# CITY OF ALBUQUERQUE

RE: **Lot 2 Block 6 Volcano Cliffs Unit 18 SAD 228**  
**7828 Urraca St. NW**  
**Grading and Drainage Plan**  
**Engineers Stamp Date 10/1/2020 (D10D003F22)**  
**Pad Certification Date 12/9/2020**

## DRAINAGE AND TRANSPORTATION INFORMATION SHEET (REV 6/2018)

|                            | GRADING AND DRAINAGE PLAN                                                          | DATE<br>9-30-20          |

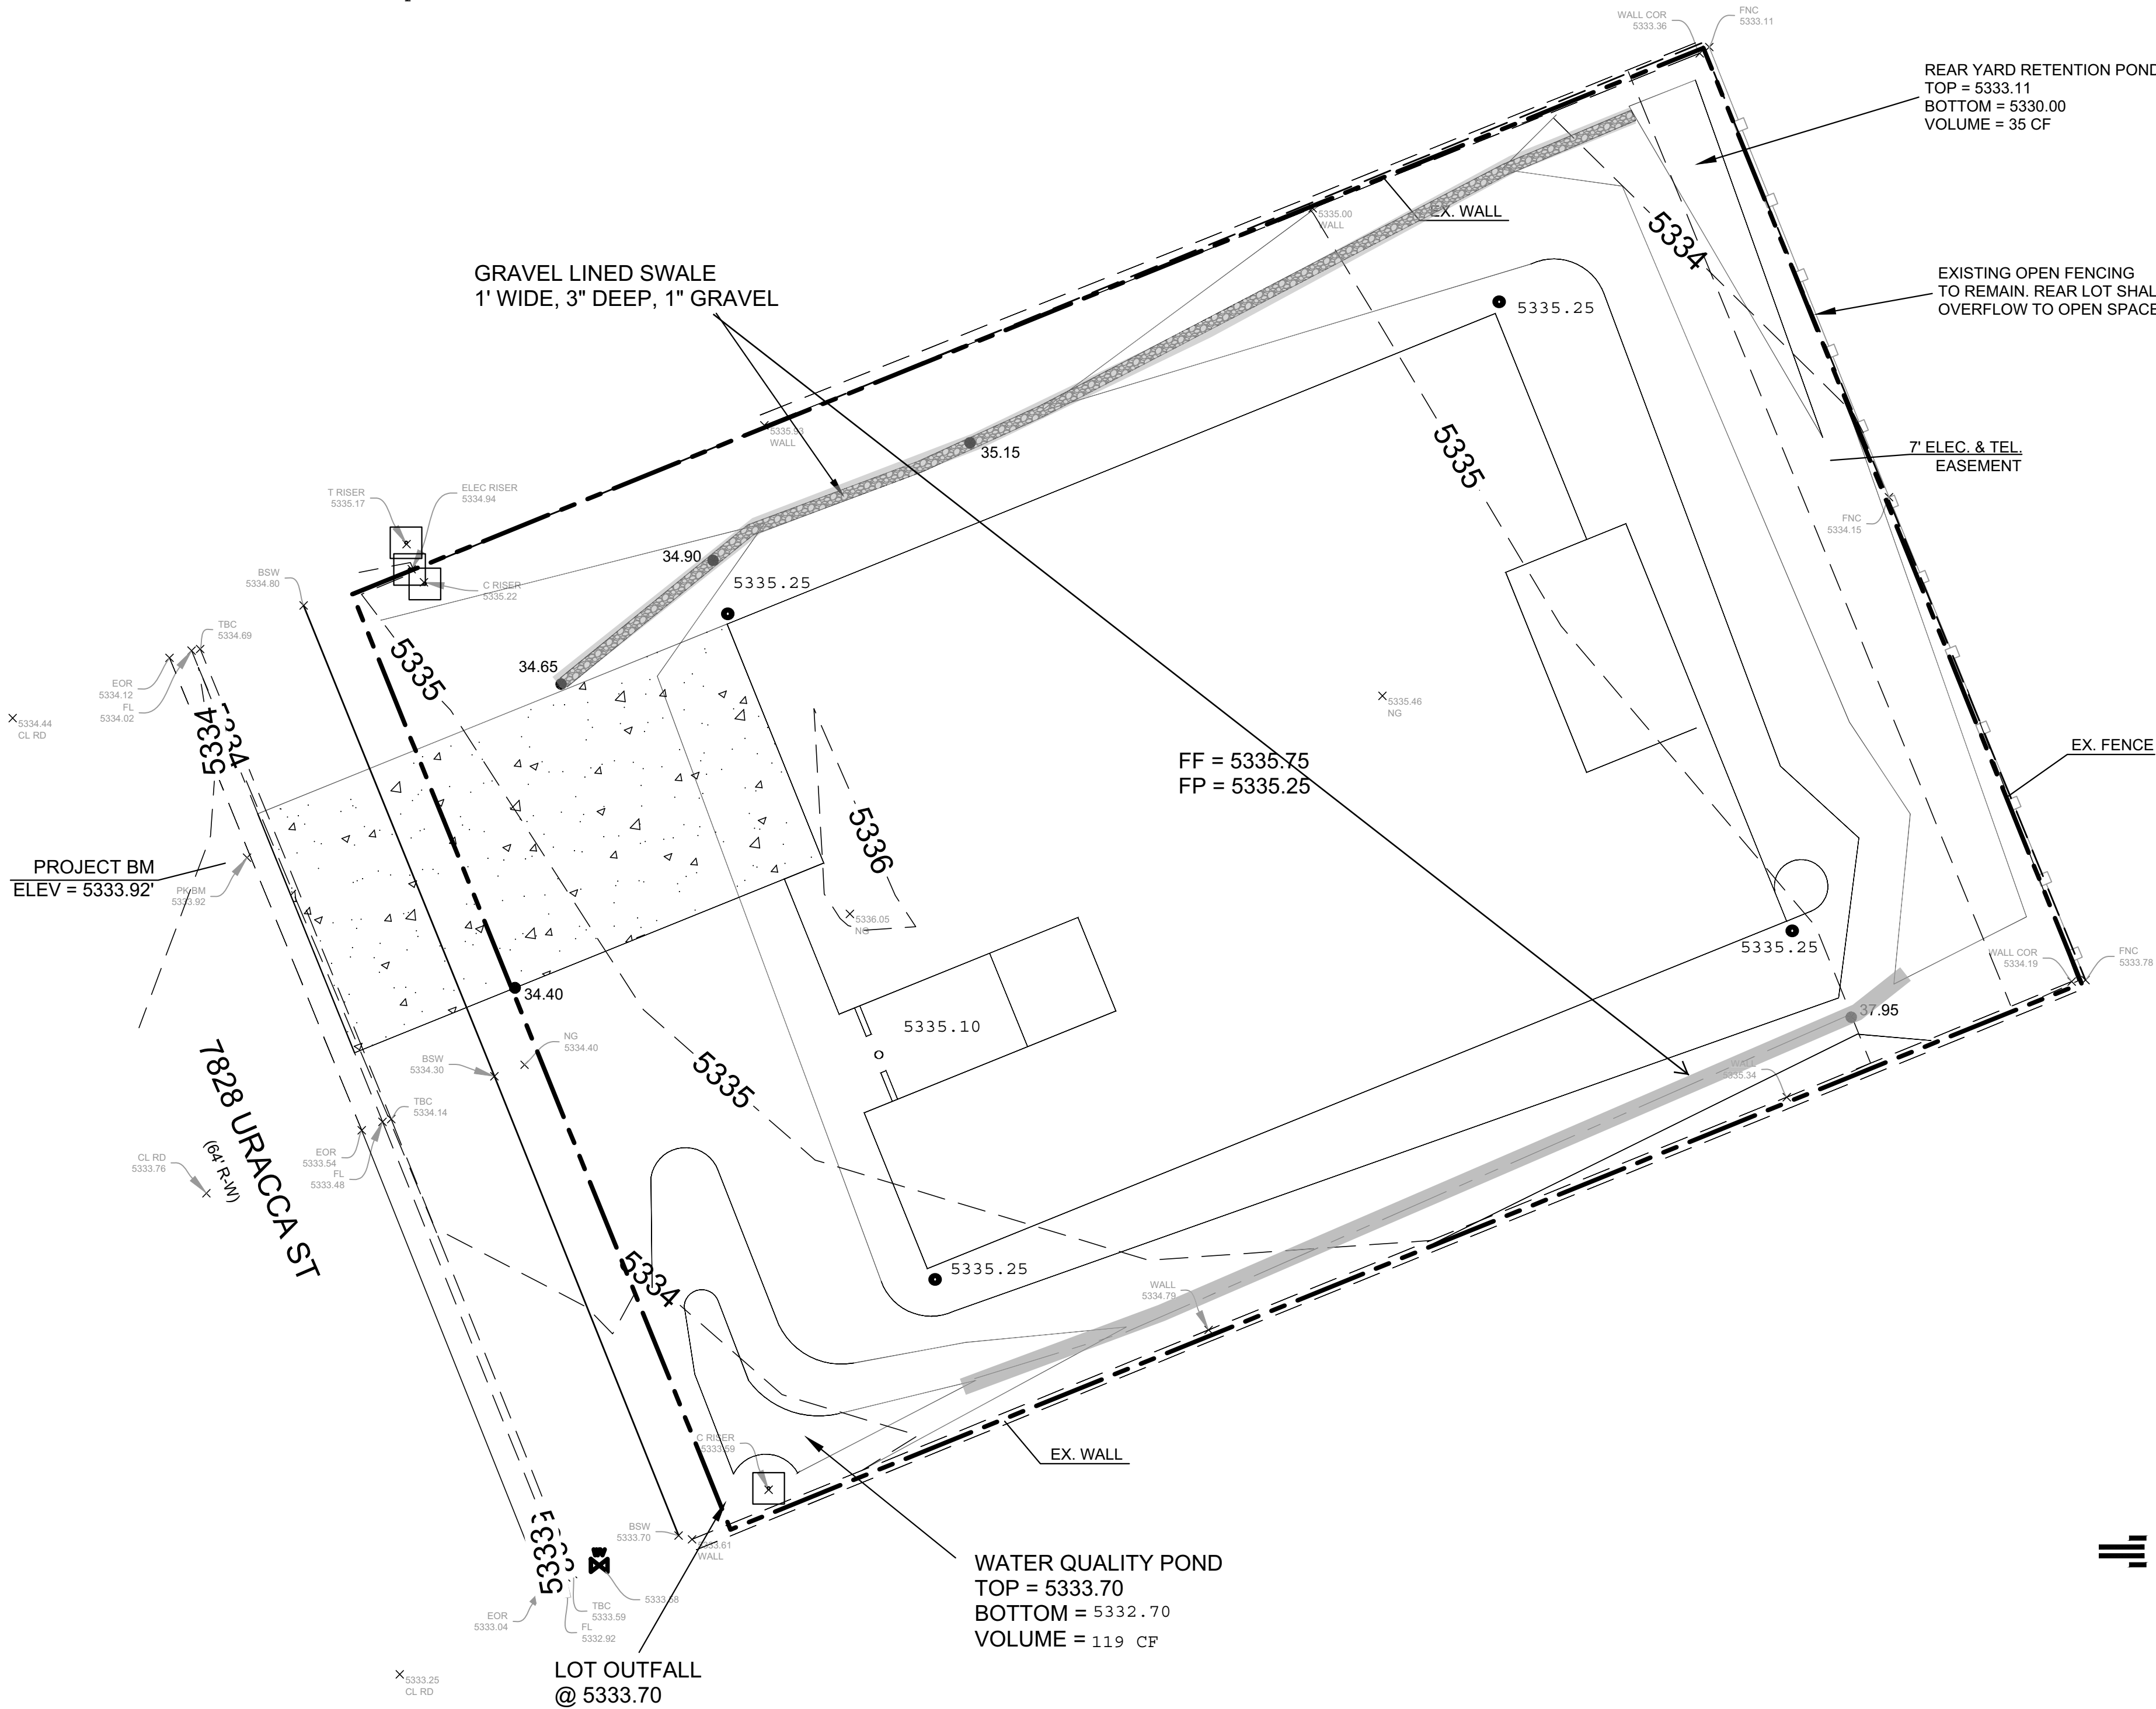
Based upon the information provided in your submittal received 12/17/2020, this plan is approved for Building Permit.

**Reiterate to the Owner/Contractor that a separate permit for a garden/retaining wall must be obtained, with the approved G&D plan and Pad Certification. Also, let the owner/contractor know that if a pool is to be added in the future the G&D plan will need to be modified showing the location of the pool and the land treatment differences.**

Prior to Certificate of Occupancy release, Engineer Certification per the DPM checklist of this plan will be required.
